From: Rik Lantz <rlantz@scst.com>
Sent: Tuesday, November 29, 2016 4:48 PM
To: Drexler, Timothy
Cc: MBizjac@scst.com; Carlos Menor Salazar; Jacki Shepherd
Subject: Sampling Plan for Urban Enterprise Institute
Attachments: Sampling Map_1410 E CHICAGO AVE.PDF

US SMELTER & LEAD REFINERY
LAKE COUNTY, EAST CHICAGO, INDIANA

1410 E CHICAGO AVE
Parcel # 450328428001000024

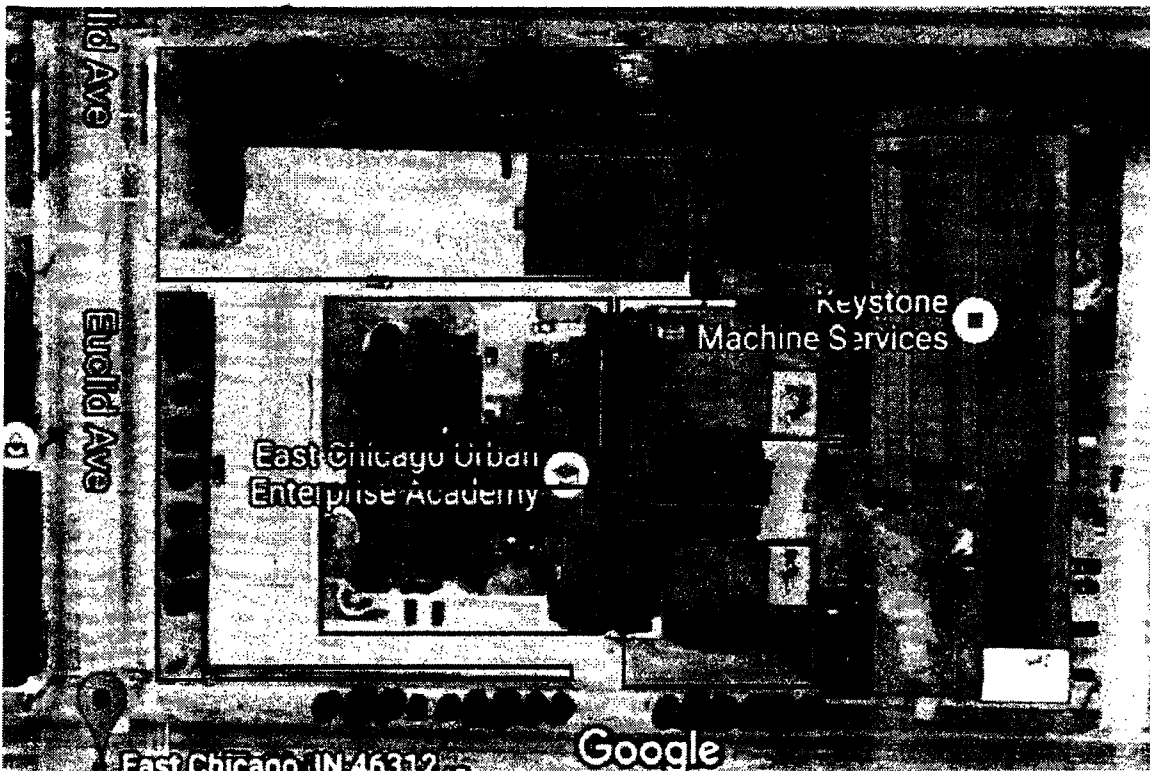
Sure. Please hook the two median strips at the south and west together to make that one L-shaped "quadrant" and there us a fence a little north of the word "keystone", please make the box that encompasses the word "machine" run up to that fence ; All I could do in adobe was make boxes, not complex shapes. Also, both of the boxes on the southern broder of the property should encompass the median that borders Chicago Ave, south of the sidewalk – please make both boxes go to the street, not the sidewalk as shown.

This looks fine, do you want me to make a sampling map?

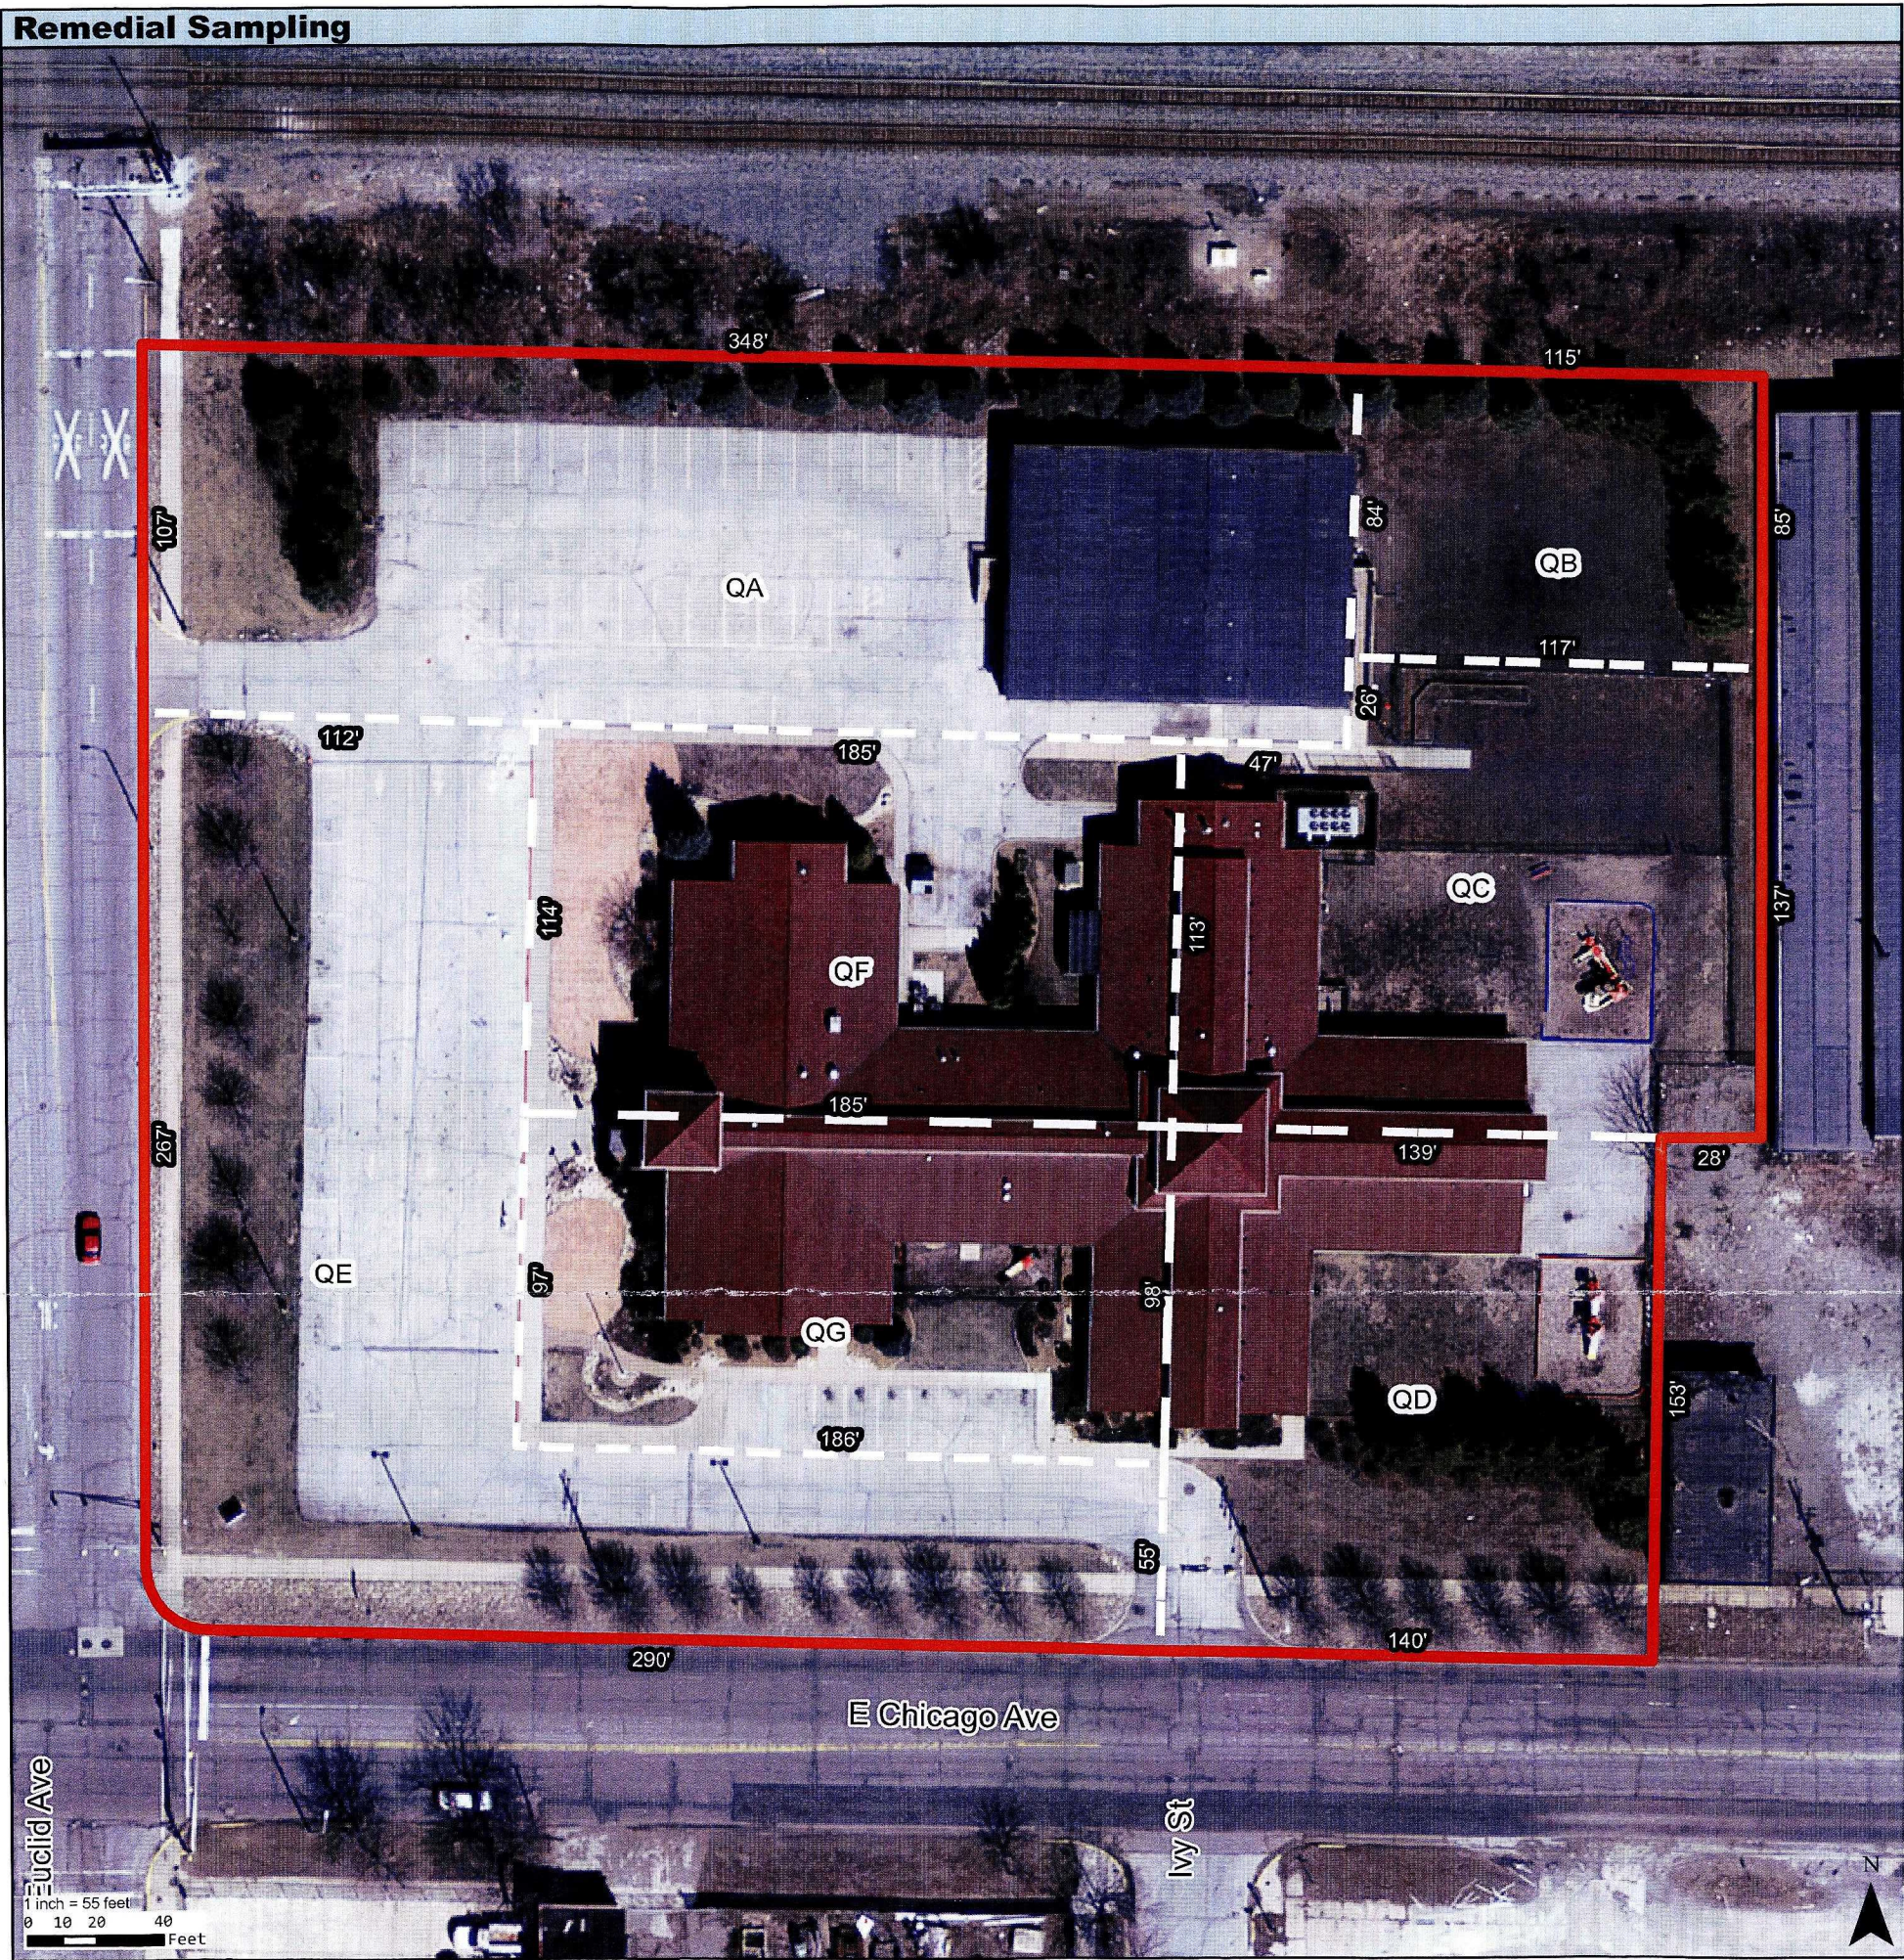
Jacki: Can you please send me a map showing the parcel boundaries of the East Chicago Urban Enterprise property at the NE corner of Chicago Ave and Euclid? It's outside or boundaries, but they want us to sample it. Does the way I divvied it up make any kind of sense relative to the parcel boundaries?
